REQUEST FOR INVITATION TO BID #2026-02
CAMPUS ELECTRICAL DISTRIBUTION
ADDENDUM III
March 4, 2026

1. **Exhibit A – Plans (v.02162026)** shall be amended to include the attached Revised C1.1 – C1.4.

ELECTRICAL PAD PROPOSED SITE PLAN
OREGON INSTITUTE OF TECHNOLOGY
3201 CAMPUS DR.,
KLAMATH FALLS, OREGON 97601

1
C1.1
PROPOSED SITE PLAN
1" = 5'

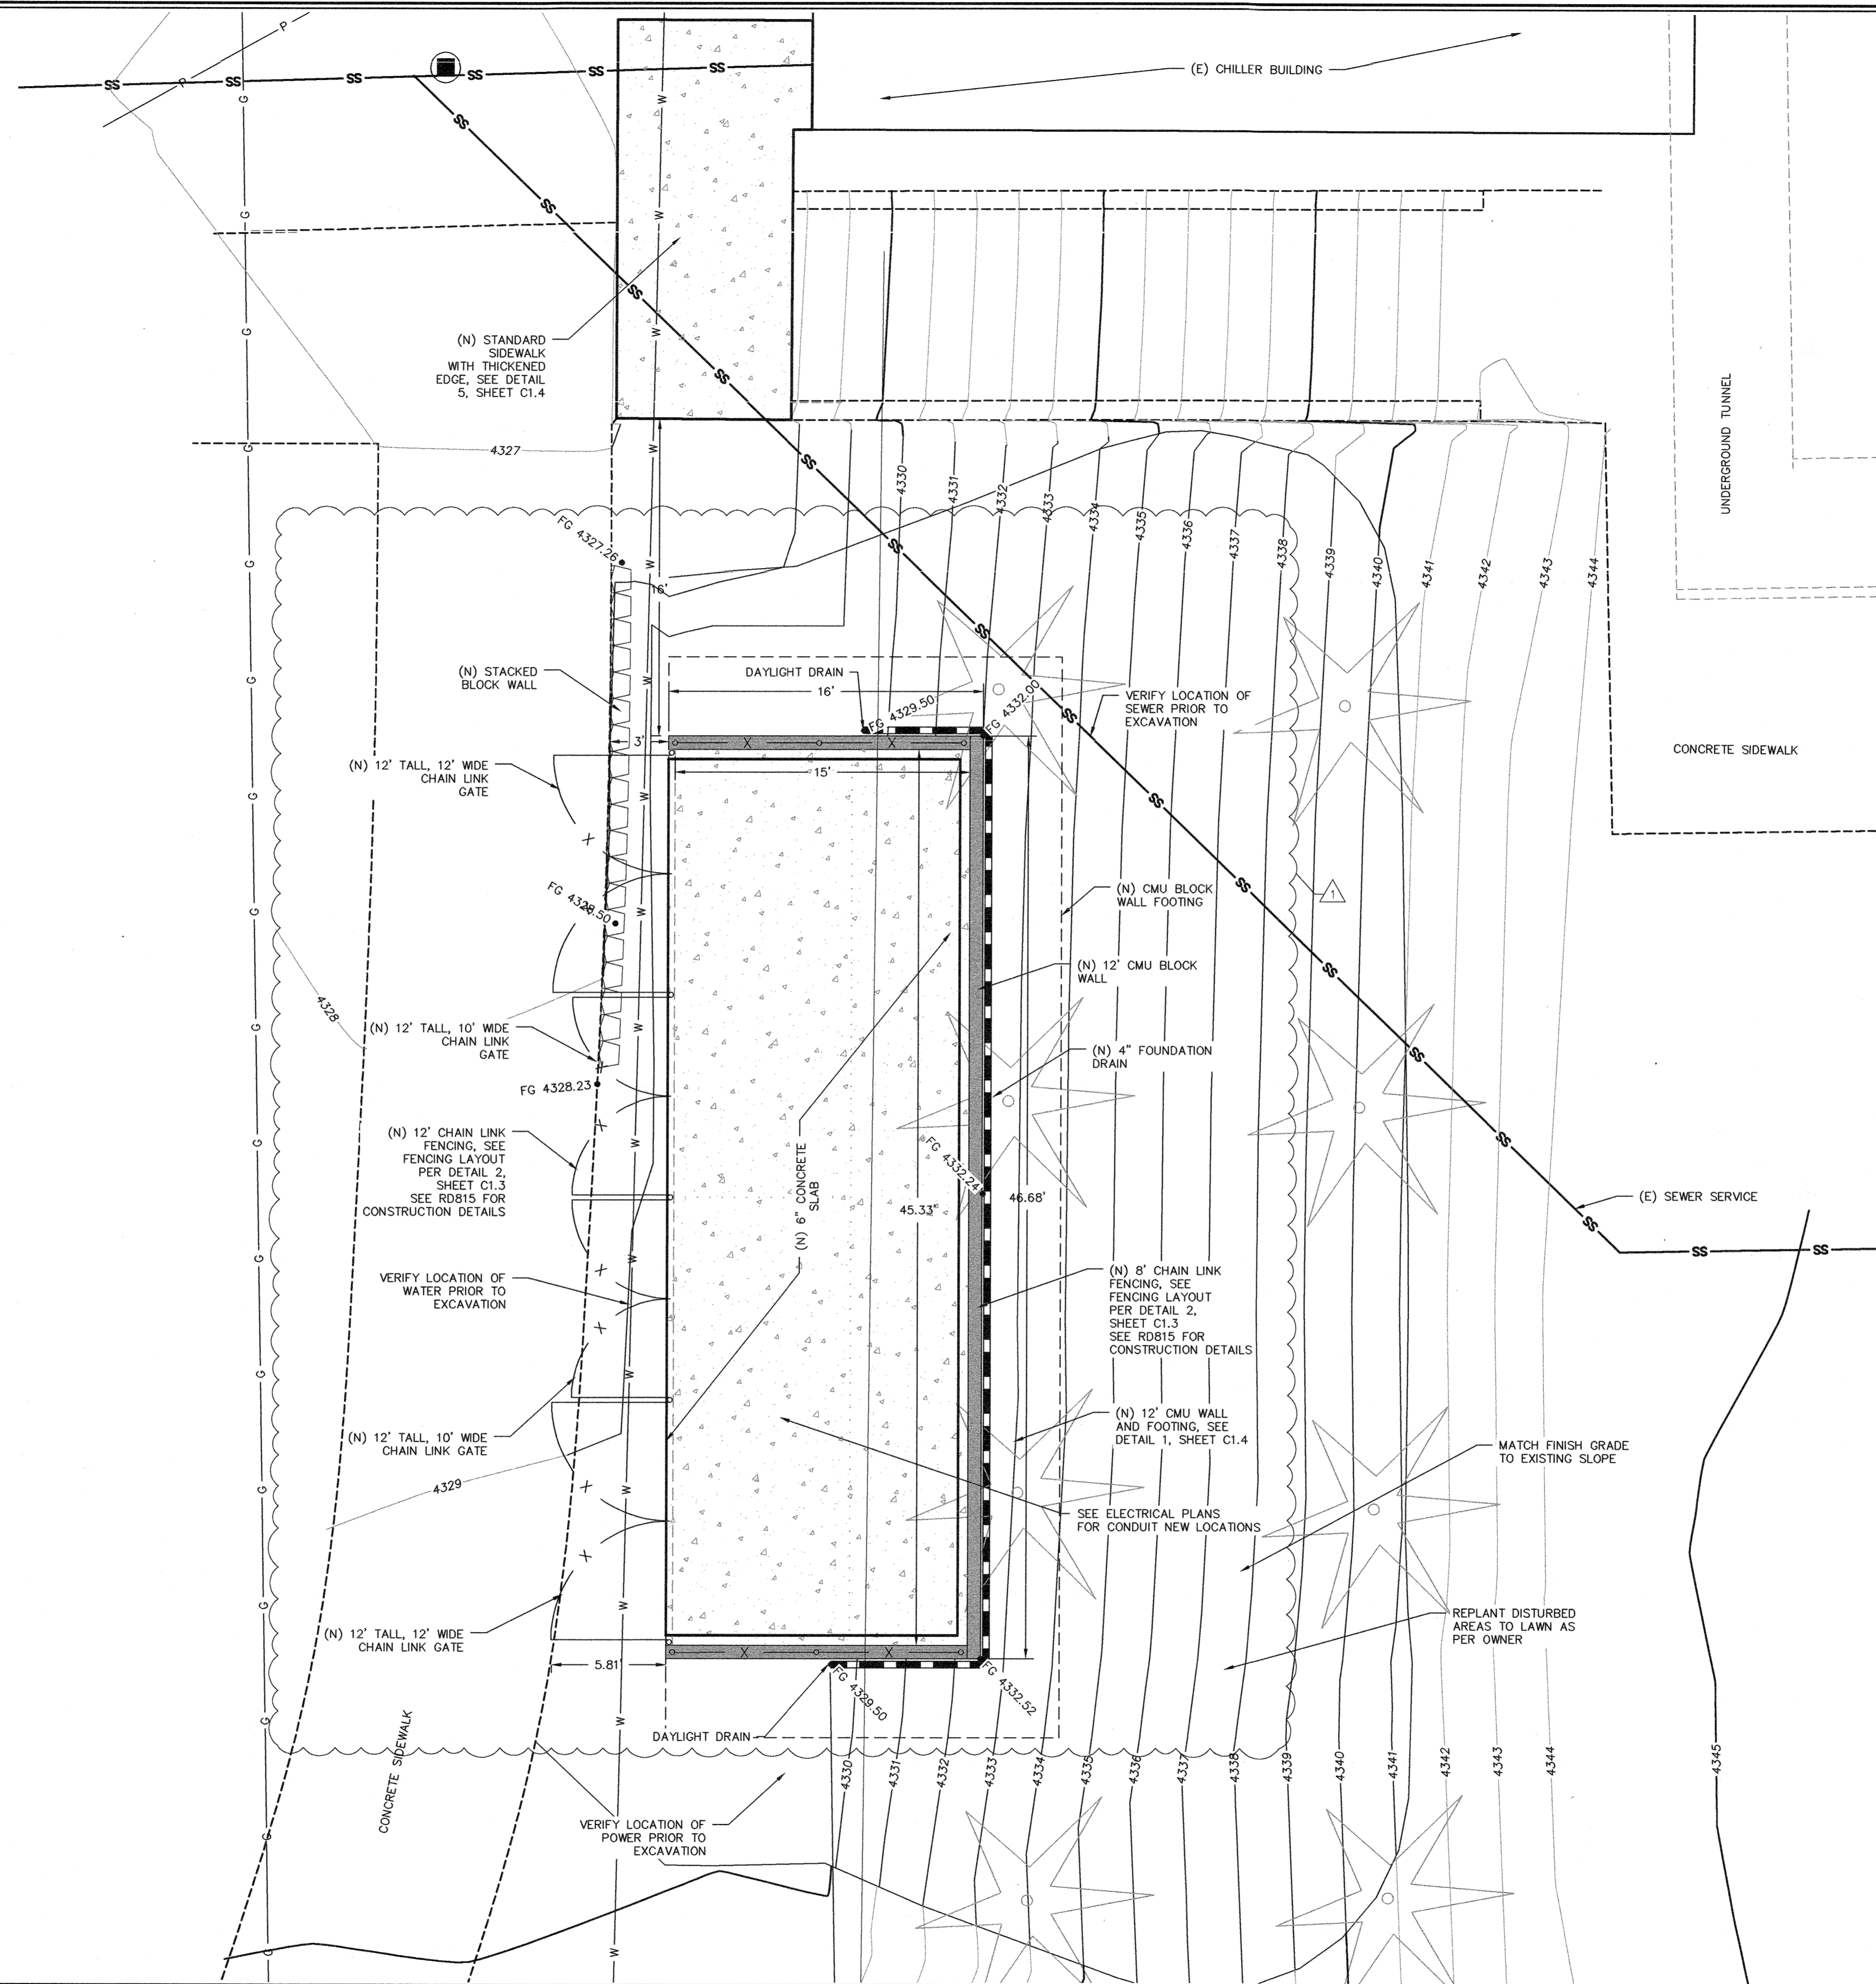
DATE	REVISION DESCRIPTION	BY
9/2/25 <td>NOTES, FIX TEXT <td>R.C.</td> </td>	NOTES, FIX TEXT <td>R.C.</td>	R.C.
3/1/26 <td>LOWER CMU WALL, REMOVE COVER</td> <td>R.C.</td>	LOWER CMU WALL, REMOVE COVER	R.C.
